**City of Kingston
Planning Committee
Meeting Number 18-2016
Addendum
Thursday October 20, 2016
6:30 p.m., Council Chamber, City Hall**

ZONING BYLAW AMENDMENT FOR ACCESSIBLE PARKING

Submission to the Planning Committee – October 20, 2016 from the Municipal Accessibility Advisory Committee RE: Planning Report Number PC-16-097

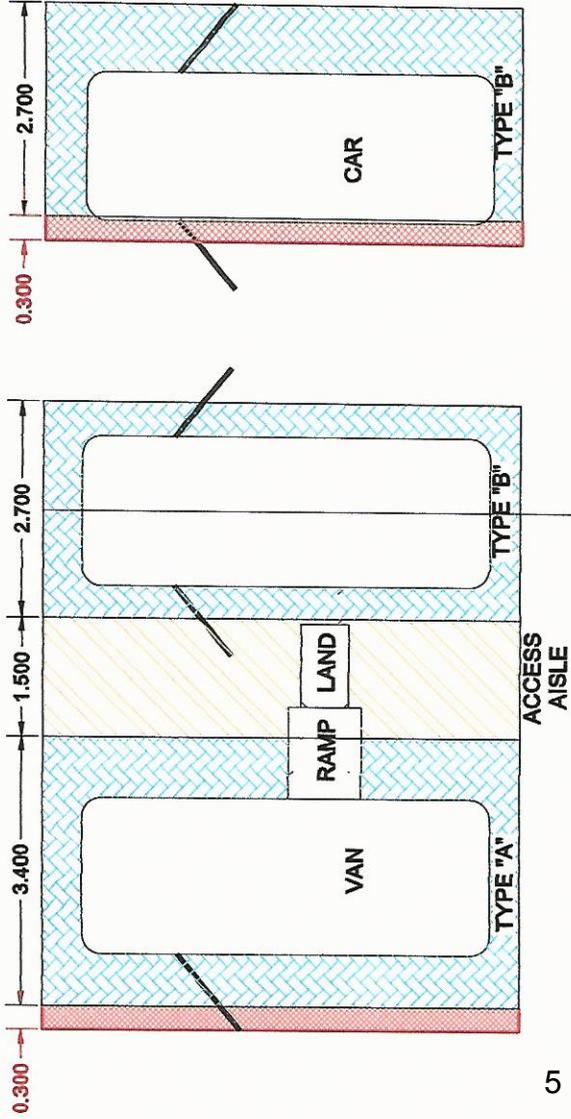
With this in mind, the Municipal Accessibility Advisory Committee (MAAC) has reviewed the draft accessible parking proposal under Planning Report Number PC-16-097 and is proposing the size of the Type "A" Van Accessible Parking Stall needs to be larger than proposed. The Built Environment Working Group of the MAAC have reviewed the proposed dimensions as shown on the attached drawing. The measurements were taken using a Honda minivan. which uses a ramp rather than a hydraulic lift. The sketch shows the driver's door fully open, ramp extended and the distance from the bottom of the ramp to the toes of the wheelchair user. This all adds up to 5.13 metres which does not include additional room for the wheelchair to get a run at the ramp. Please consider that in the winter with slush on the tires, taking a short run at the ramp is necessary. The proposed total 4.9 metre width (3.4+1.5) is just not wide enough. Also consider if a lift were being used rather than the ramp which starts within the vehicle. the lift itself would be 1.2 metres with a short fold-down ramp of about 0.075 and a required clearance for the lift of 0.05 metres from the body of the van which would add approx 0.150 metres to the dimensions.

MAAC **proposes** that the width of a Type "A" stall be increased by 0.3 metres to 3.7 metres wide with a 1.5 metre access aisle making a total width of 5.2 metres which a minivan with a side ramp extended will fit within.

Also included in the attachment are the dimensions of a car (Chevrolet. Impala) . The car plus the one door fully open is 2.94 metres wide in a proposed 2.7 metre wide stall and 3.6 metres wide with both doors open, In order for this car to open the passenger door fully when parking in a Type "B" stall, The driver would have to park with the driver's side of the car encroaching 0.24 metres into the access aisle in order to ensure full use of the door. Adding 0.3 metres to the width of the Type "B" stall would allow better access to the stall with full use of the doors.
